Building Code of Australia 2022 Report

Report for BCA Compliance

PROJECT NAME: Richmond River High Campus
PROJECT NUMBER: GDL240132.1
DATE: 15/07/2025 (Rev F)

Figure 2 - Overall Site Context Plan (Source: EJE Architecture)

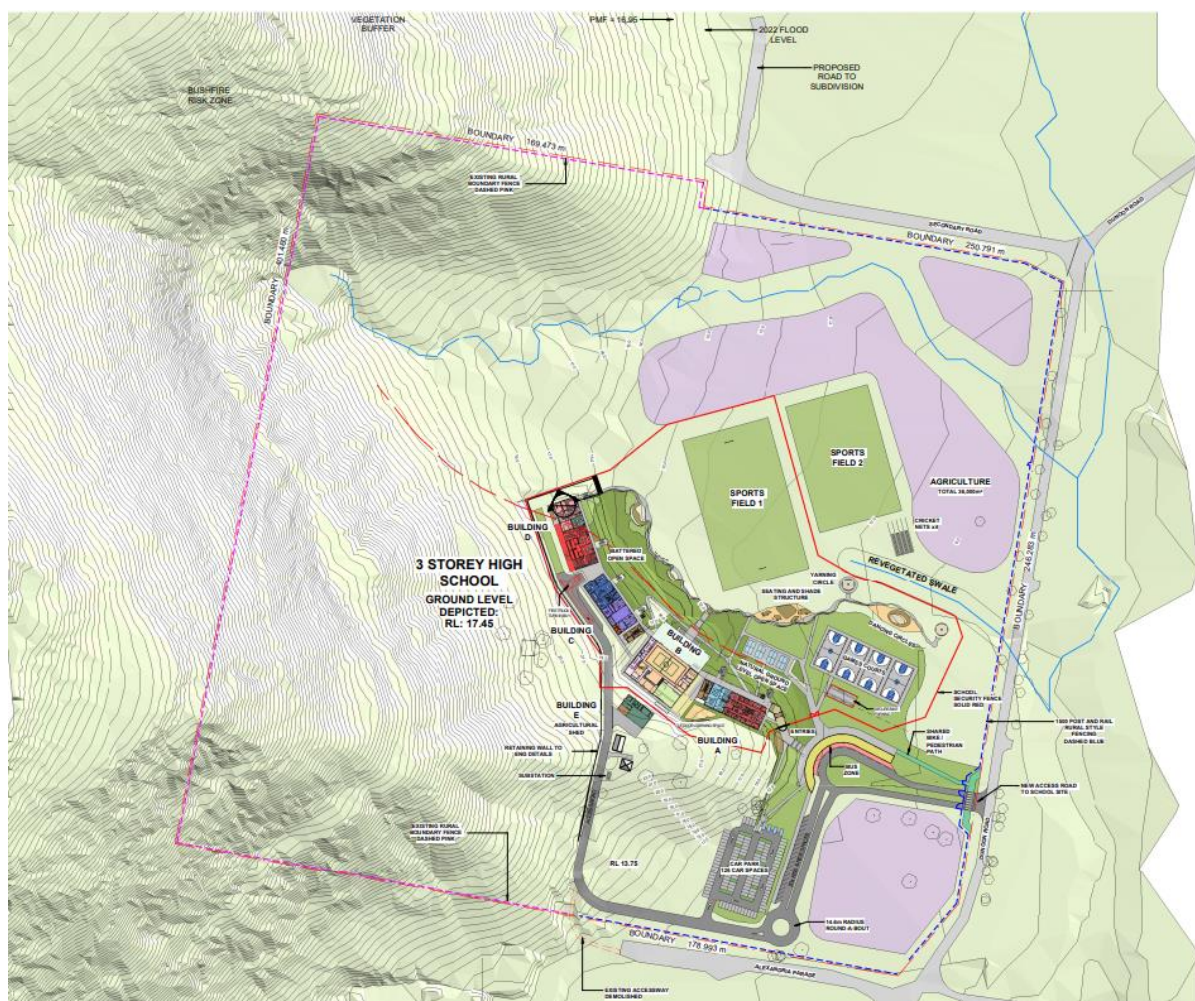
- The architectural drawings indicate there are three (3) distinct buildings which are connected via the roof structure to form a single combined building. May need to consider as a combined building of Type A Construction. The alternative may include a fire engineering - performance solution so can assess as 3 separate buildings rather than a large, combined building. The advantage is that the single storey buildings can be designed as Type C construction with each building being assessed as a separate fire compartment.

- The maximum size of fire compartments for a Class 5 and 9b building of Type A construction is 8,000m² with volume up to 48,000m³. Whilst a Class 9b building of Type C construction being 3,000m² with a volume up to 18,000m³. The overall floor area and volume of the building being established to determine the appropriate location of firewalls to provide fire separation in accordance with Table C3D3 of the BCA.

- The proposed buildings is situated across the 3 allotments which creates multiple technical non-compliances with the BCA:
 - (a) External walls situated within 3.0m to the allotment boundary is required to achieve an FRL;

(b) Window and doorway openings within 3.0m to the allotment boundary is required to be protected.

These departures from the DtS provisions can be readily address via a performance solution from a fire engineer to comply with the performance requirements of BCA 2022.

The consolidation of the 3 allotment into a single allotment will mean this performance solution will no longer be required. Verification of the consolidation to a single allotment being address at the crown certificate stage.
